**Re: Wastewater System Design Amendment for:
Sargeant Relocate – 90 Lindens Road, Koromiko
MDC Building Consent Number: 130569
Our Ref: 3766**

Appendix A: Site Plan and Wastewater Detail: 3766- G10

PROJECT	SERGEANT RELOCATE 90 LINDENS ROAD, KOROMIKO
DRAWING	SITE PLAN WASTEWATER DETAIL

▪ **On-site Wastewater Management Report**

DWG NO.
3766-G10

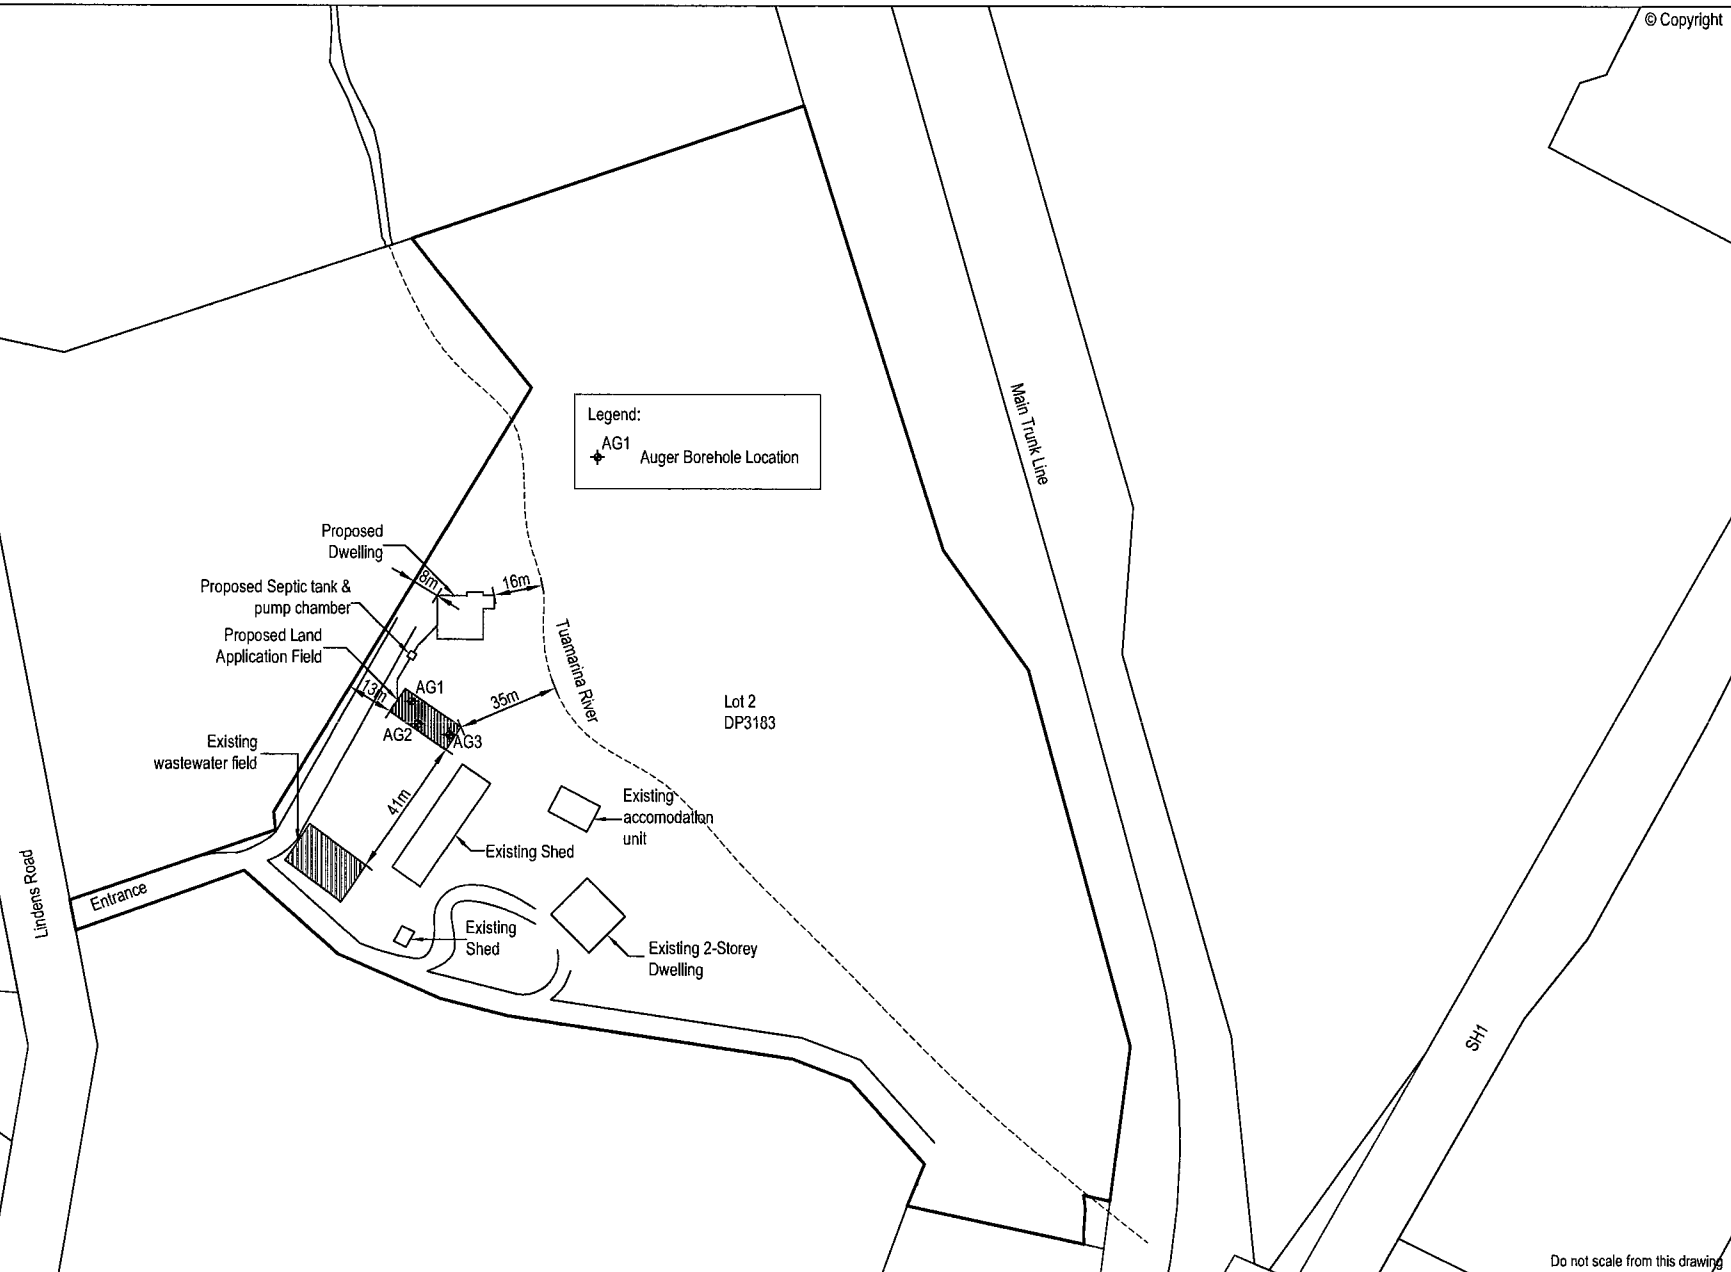
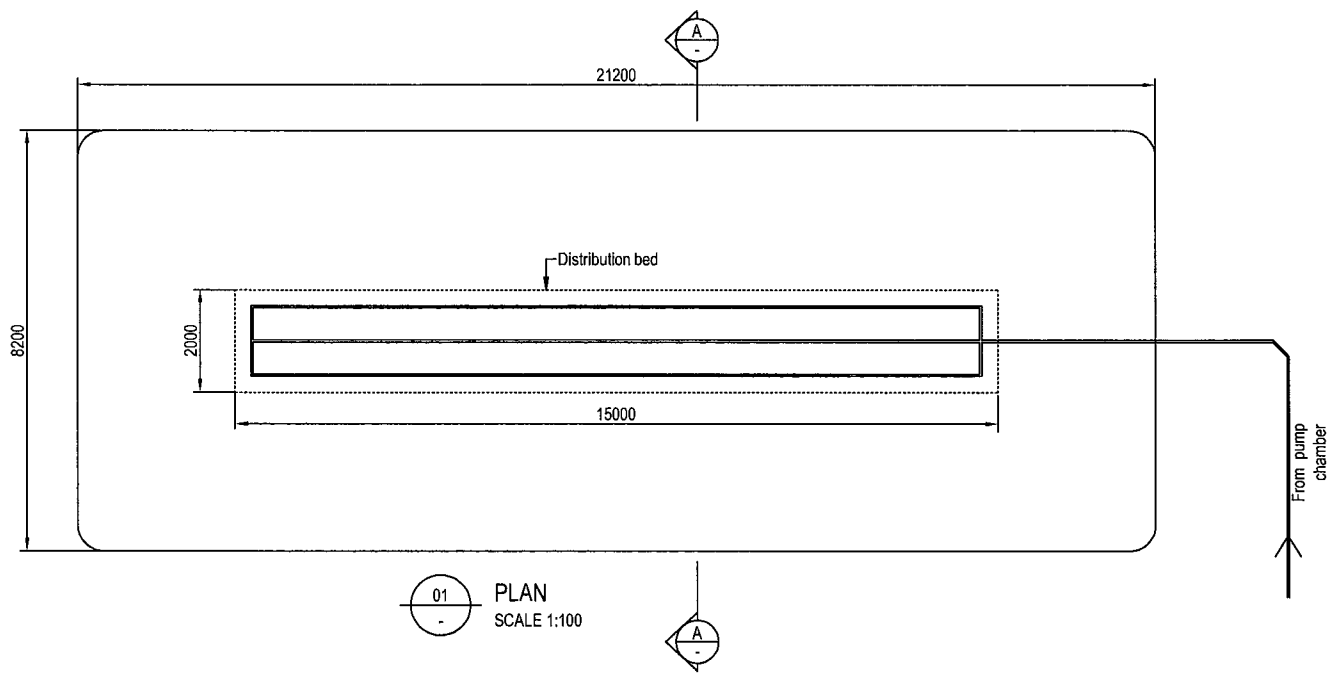
We have been asked to look at the use of an alternative wastewater management system for the above address. Our current design currently details a primary treatment unit and mounded land application area. Our client has informed us that they would like to look at the use of a secondary treatment unit. We have reviewed the site investigation and our design and have found that an alternative system involving a secondary treatment unit and land application via raised subsurface drip line application is also acceptable when average site topography, soil conditions and groundwater levels are taken into account.

A suitable site for the new land application system exists where the original proposal and site testing was completed, south-west of the relocated dwelling.

A site plan outlining the area concerned is contained in drawing 3667-G10 in Appendix A.

The total area of drip line required for any new wastewater system is 343m² (refer wastewater design sheet in Appendix B). The irrigation system design requires 1.6 litre/hr emitters at 0.6m spacing with lines laid at 1.0m intervals.

The proposed land application area achieves a minimum 30m setback from the Tuamarina River bank and 35m from the existing mounded land application system servicing the main house.
